Hinweis für Befestigungsmaterial der *multipac* Griffe
Information assembly material of *multipac* handles
Information pour matériel de fixation des poignées

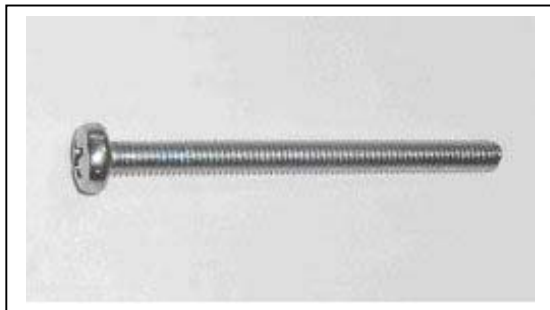
Bisherige Ausführung:

Befestigung der Griffe erfolgte über eine Schraube **M4x50** mit Kreuzschlitz - Antrieb.

Voraussetzung:

Seitenwand hat vorgeschchnittenes Gewinde M4.

**Existing version:**

The assembly of the handles was done with a **M4x50** screw with pozi drive.

Conditions:

The side panel have a M4 thread.

**Neue Ausführung:**

Befestigung der Griffe erfolgt über eine **selbstformende** Schraube 4x50 mit Torx-Antrieb (T20).

Voraussetzung:

Seitenwand hat **kein** vorgeschchnittenes Gewinde.

New version:

The assembly of the handles is done with a 4x50 **self tapping screw** with Torx (T20).

Conditions:

The side panel doesn't have a thread.
